SHELDON PLACE SUBDIVISION, FIRST UNIT,
RESUBDIVISION OF LOTS 1, 2, 6 AND 7

APPLICATION NUMBER 3 DATE October 21, 2021

DETAIL SITE PLAN

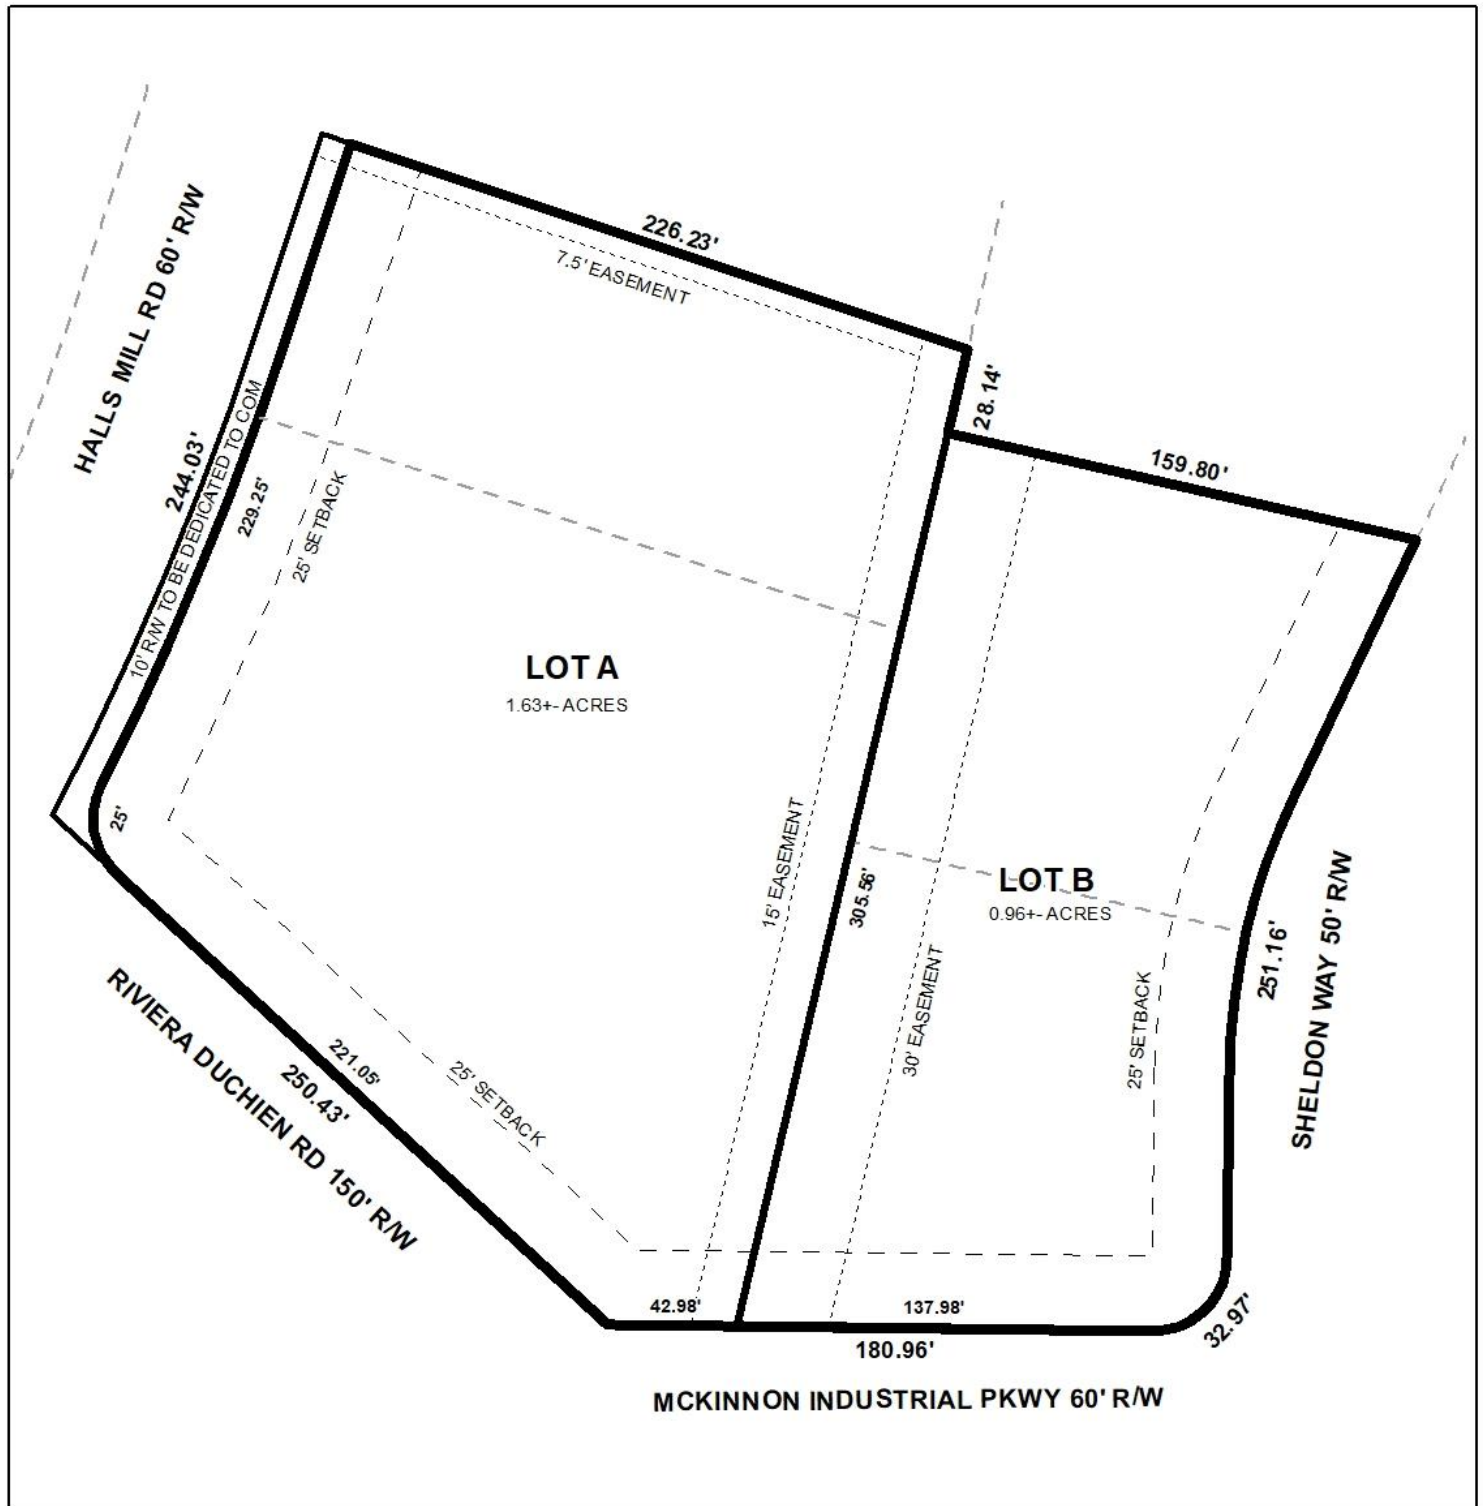
The subject site has four street frontages. The primary frontage is along Halls Mill Road, a collector street with a 60-foot right-of-way, and a planned 70-foot right-of-way. The preliminary plat indicates a current right-of-way width of 25 feet from the centerline, and proposed dedication of ten feet to provide the required 35 feet from centerline. This dedication should be retained on the Final Plat, if approved. The other streets fronting the site are minor streets. Riviere du Chien Road has a compliant right-of-way width of 150 feet, and Mackinnon Industrial Parkway has a compliant right-of-way width of 60 feet; therefore, no dedication would be required along those frontages. Sheldon Way has a 50-foot right-of-way width without curb and gutter, and normally requiring a 60-foot right-of-way. However, as Sheldon Place Subdivision, First Unit was recorded without the requirement for frontage dedication along Sheldon Way, dedication should again not be required. The right-of-way widths of all streets should be retained on the Final Plat, adjusted for any dedication along Halls Mill Road. A compliant 25-foot radius curve is indicated to be dedicated at the intersection of Halls Mill Road

It should be noted that the plat erroneously has Mackinnon Industrial Parkway spelled as McKinnon Industrial Parkway. This spelling should be corrected on the Final Plat, if approved.

As on the preliminary plat, the 25-foot minimum building setback line should be illustrated on the Final Plat, as measured from any required dedication. The proposed lots meet the minimum size requirements of the Subdivision Regulations, and the lot size labels should be retained on the Final Plat, adjusted for any required dedication, or a table should be furnished on the Final Plat providing the same information, if approved.

The plat indicates two power and utility easements and one drainage easement within the site. Therefore, a note should be required on the Final Plat stating that no structure may be constructed or placed within any easement without the permission of the easement holder.

- 1) retention of the dedication to provide 35 feet from the centerline of Halls Mill Road on the Final Plat;
- 2) retention of the dedication to provide a 25-foot radius curve at the intersection of Halls Mill Road and Riviere du Chien Road on the Final Plat;

- 3) retention of the right-of-way widths of all streets on the Final Plat, adjusted for any required dedication along Halls Mill Road;
- 4) correction of the spelling of Mackinnon Industrial Parkway (from McKinnon Industrial Parkway) on the Final Plat;

- 5) retention of the 25-foot minimum building setback line on the Final Plat as measured from any required dedication;
- 6) retention of the lot size labels on the Final Plat, adjusted for any required dedication, or the furnishing of a table on the Final Plat providing the same information;

- 7) placement of a note on the Final Plat stating that no structure may be constructed or placed within any easement without the permission of the easement holder;
